**P22-15**  
**Root 18 CrossFit Addition and Parking**  
**Revised**

Property Owner: Van-Park Properties LLC  
 Applicant: Carlin Vandendriessche  
 Location: 600 West Liberty Street  
 Zoning: C-1 (Local Commercial)  
 Request: Site Plan and TC-OV approval for a building addition, building alterations, and parking expansion

**SITE, PAVING & UTILITY PLAN**

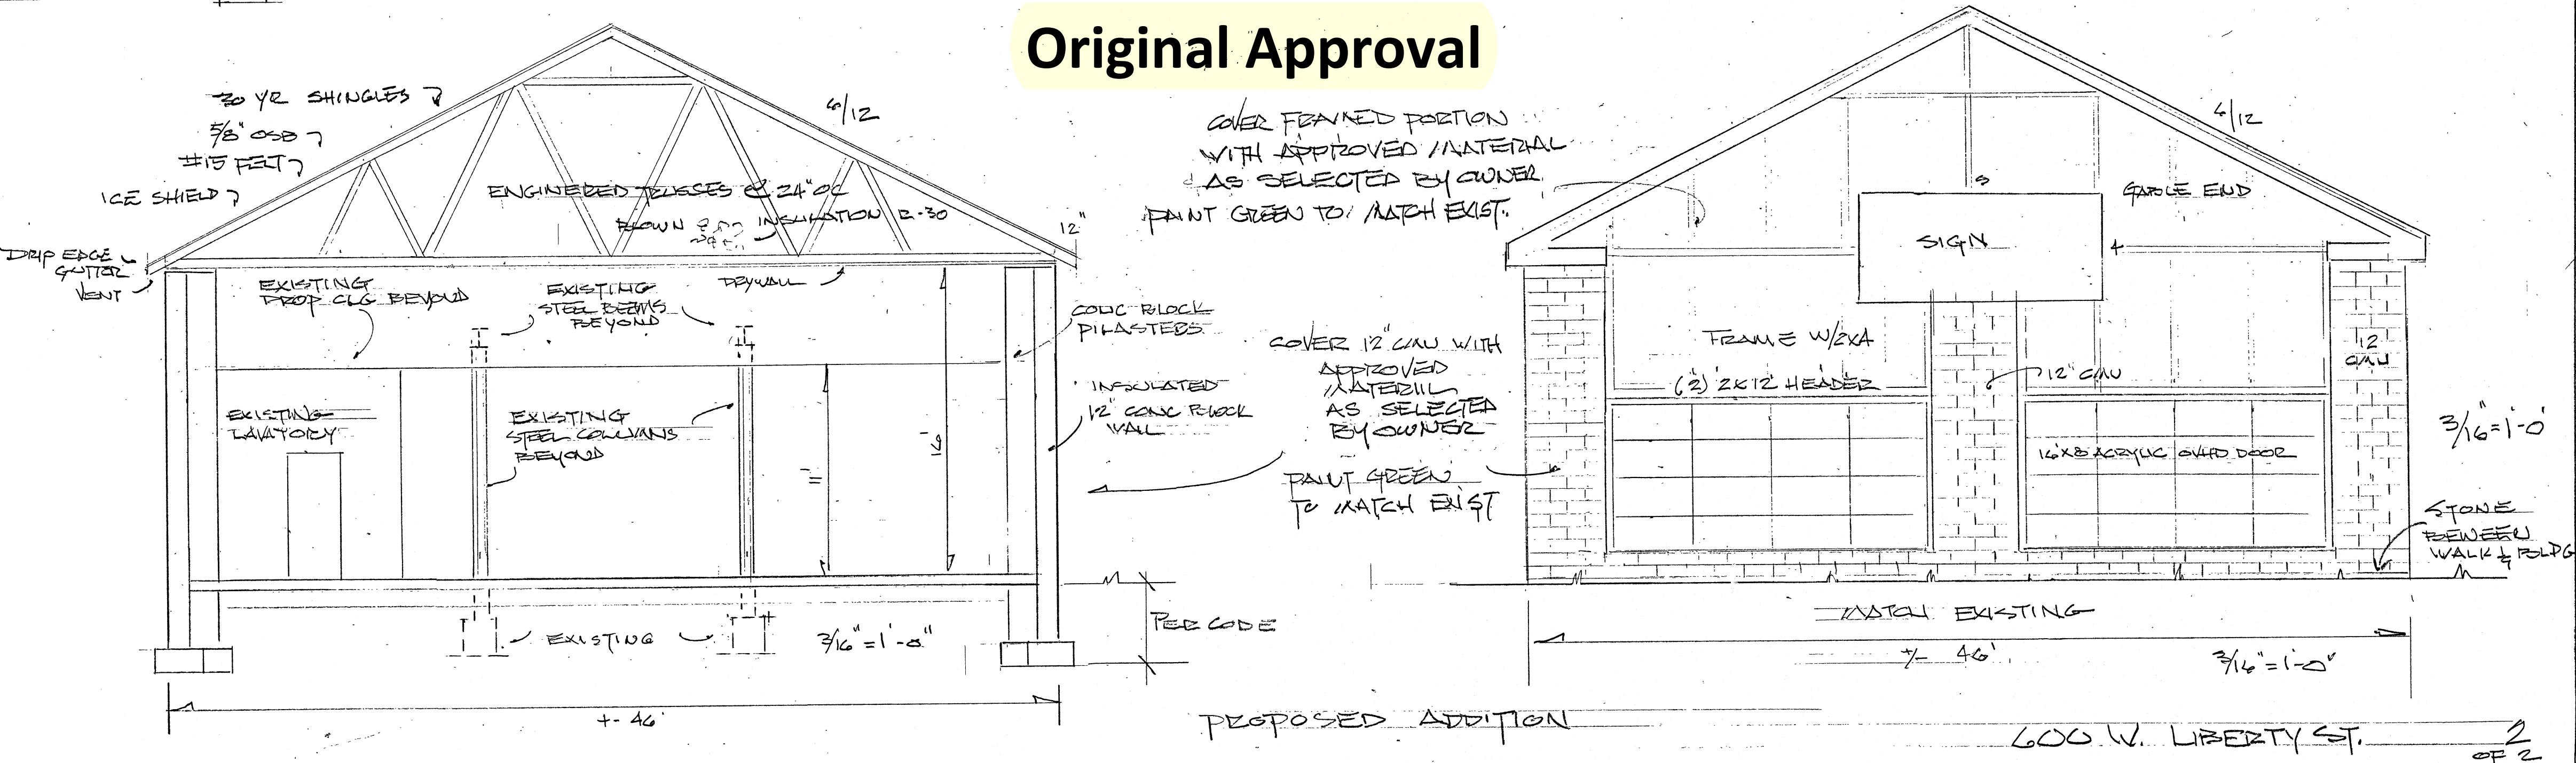
Access and Circulation – The proposed site will have a one-way counterclockwise circulation with ingress south of the existing building and egress on the south side of the property.

Required Off-Street Spaces – The subject use falls under the definition of “Personal and Professional Services” which requires a minimum of 1 parking space for every 300 sq. ft. of floor area, which can be exceeded by 20%. The total 5,606 sq. ft. building thus requires between 19 and 23 parking spaces. The site plan indicates 22 parking spaces.

Parking Dimensional Standards – Angled parking spaces must be 9 ft. x 18 ft. with a 13 ft. one-way drive aisle. The proposed parking lot meets these standards.

Parking Lot Landscaping – Per Sections 1145.04(g) and 1145.09(b), parking lots must be setback 10 ft. from any street right-of-way and must contain landscape features or other visual barriers. Parking is shown at a 2 ft. setback from the right-of-way with no visual barrier, which has received a variance from the Board of Zoning Appeals.

Staff recommends **approval** of revised application P22-15 as submitted, with the condition that parking lot lighting shall be provided in compliance with Section 1145.09(c).

2 FRONT ELEVATION (NORTH)  
SCALE 1/4" = 1'-0"

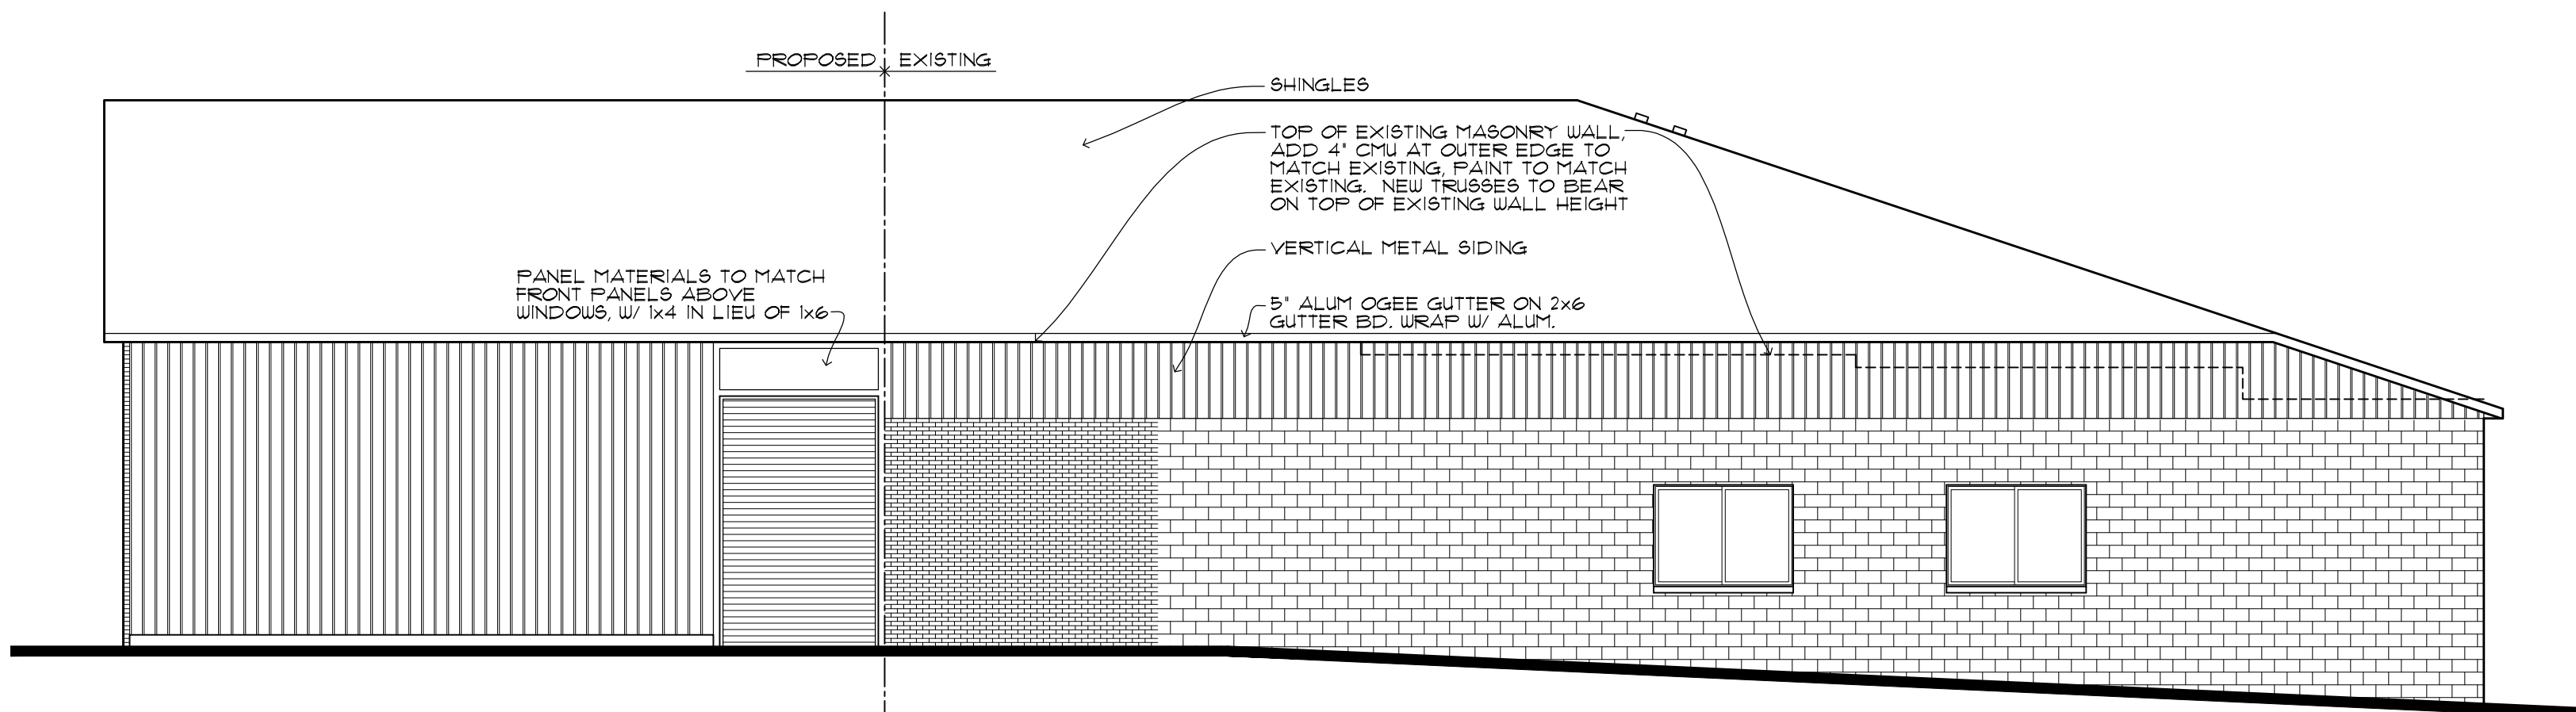
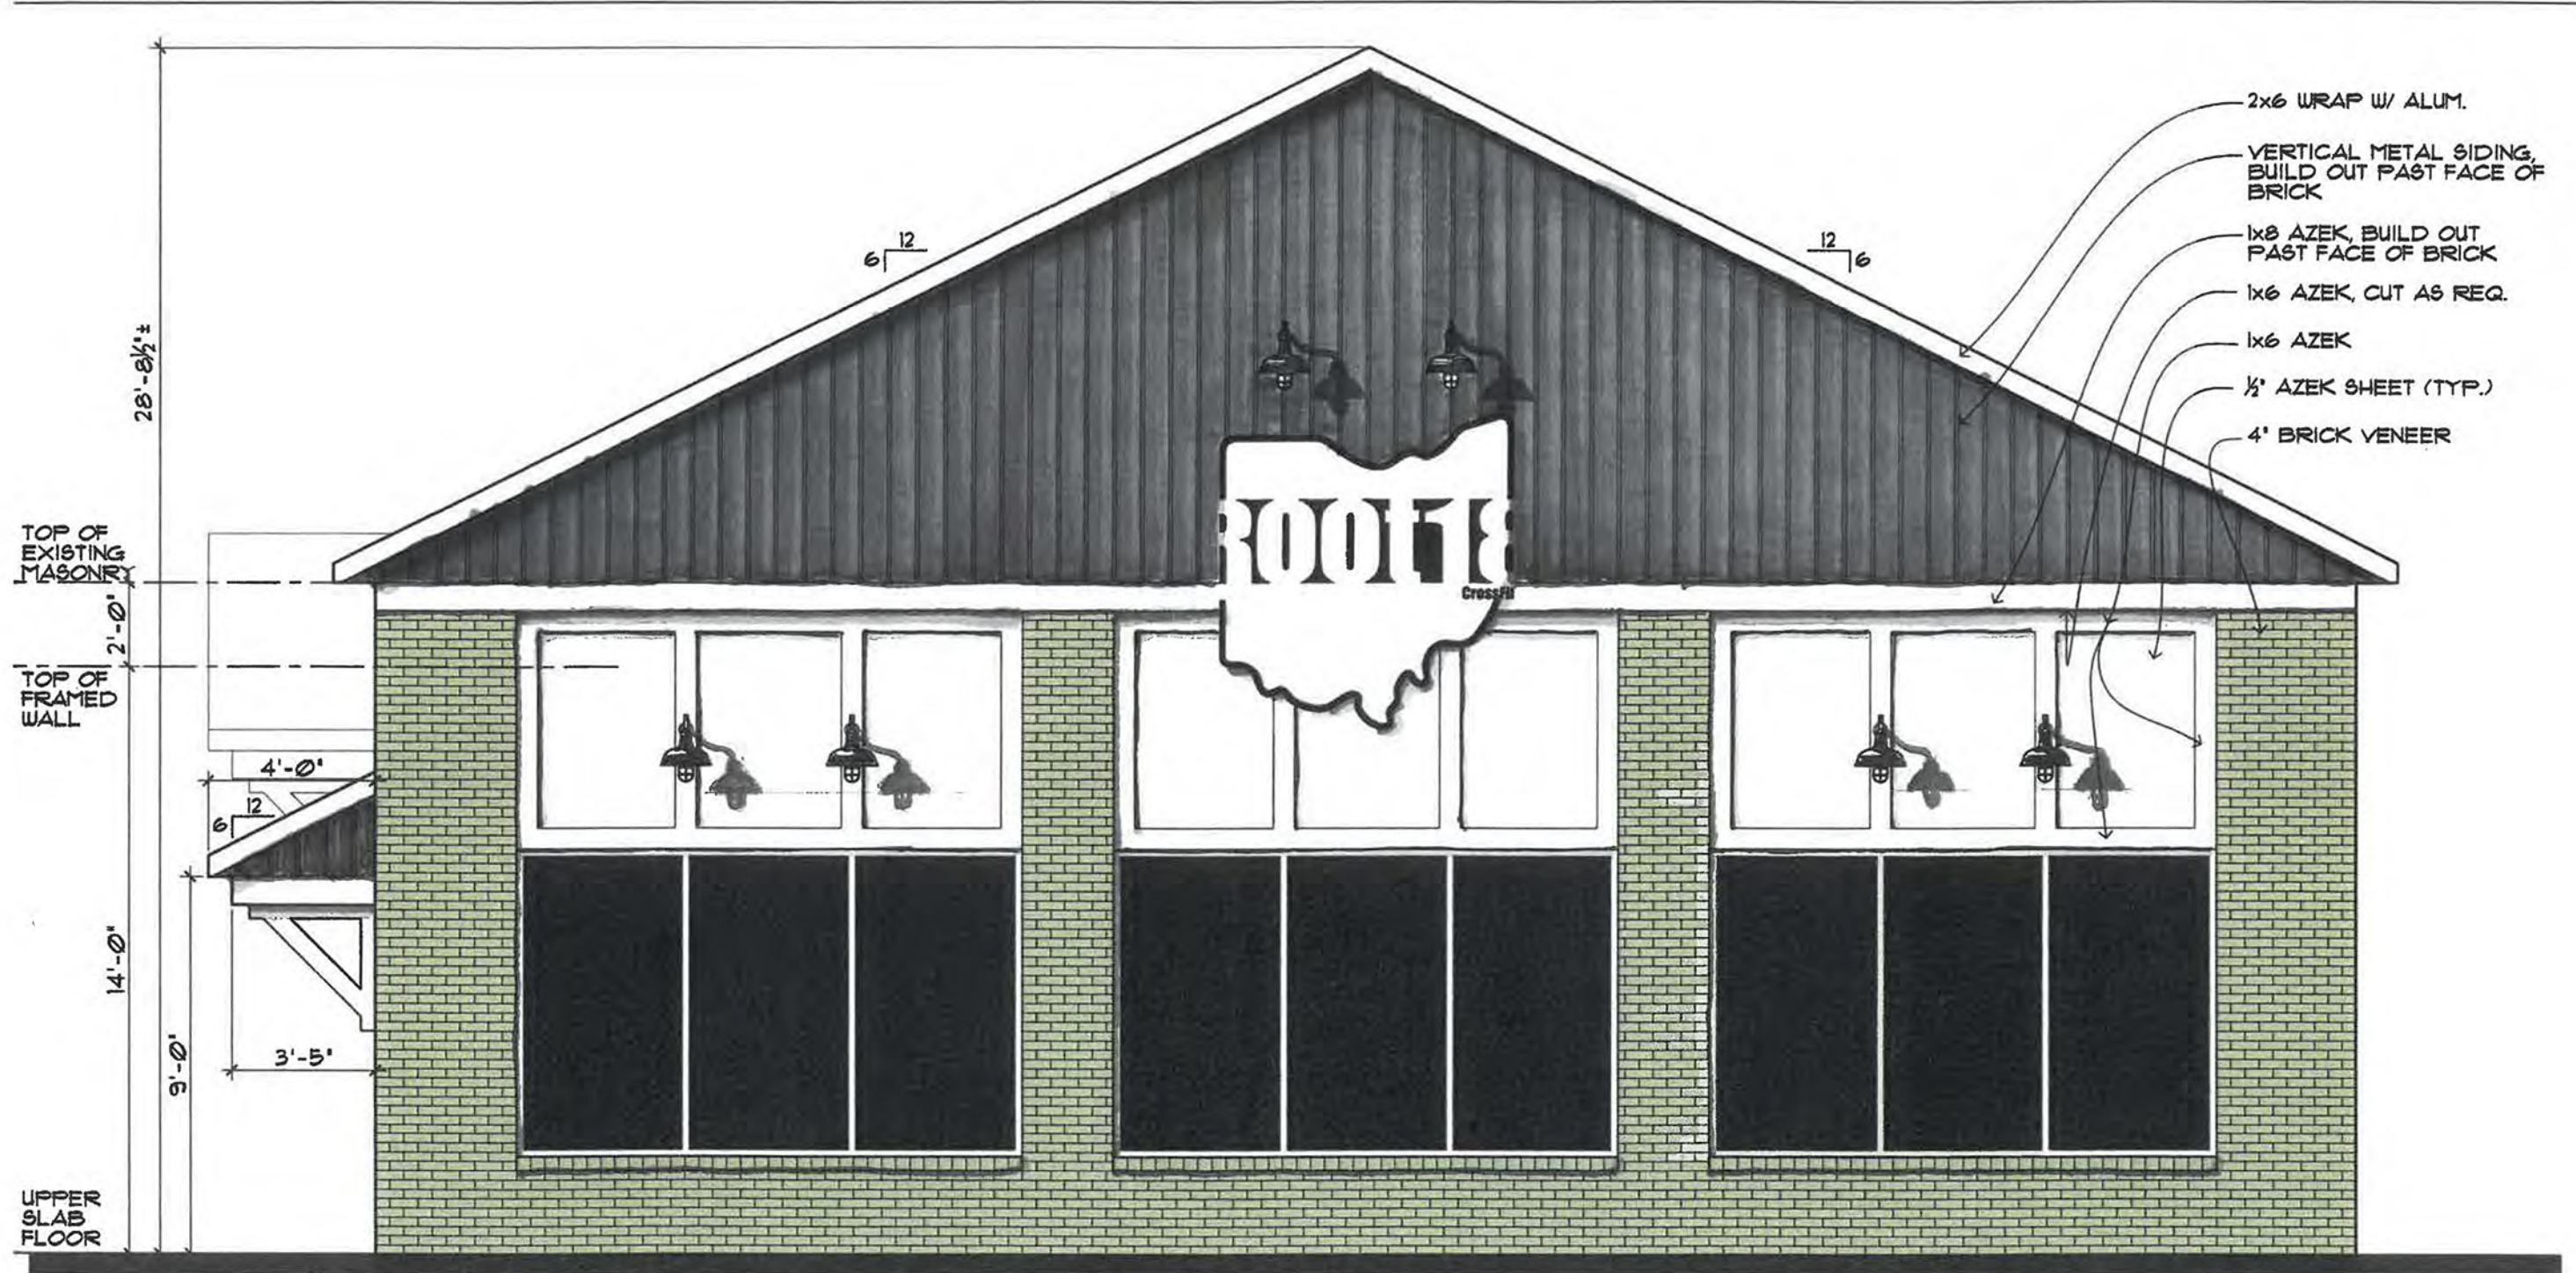
The front of the addition will have lower areas with green brick veneer and upper areas with gray vertical metal siding. The front will also have three large windows with white Azek features above them and decorative lighting.

4 SIDE ELEVATION (WEST)  
SCALE 1/8" = 1'-0"

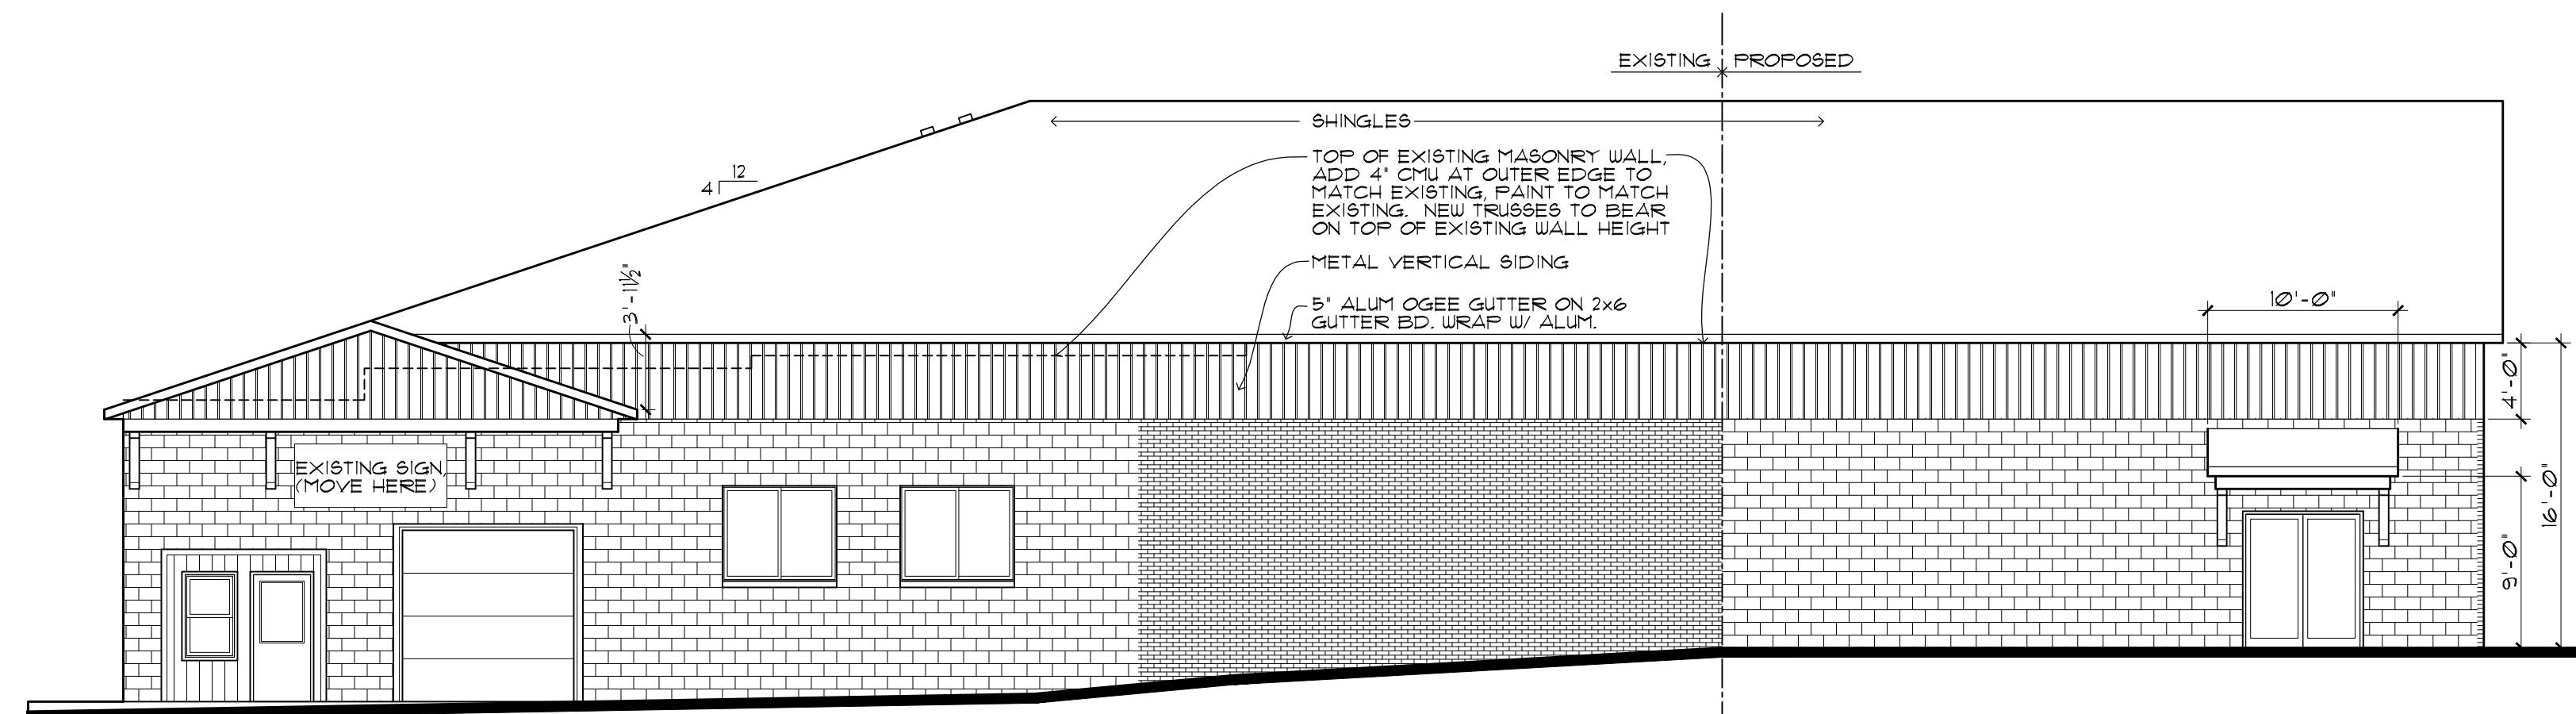
The west side of the addition will incorporate white vertical metal siding. Vertical metal siding will also be added to the upper portion of the existing building.
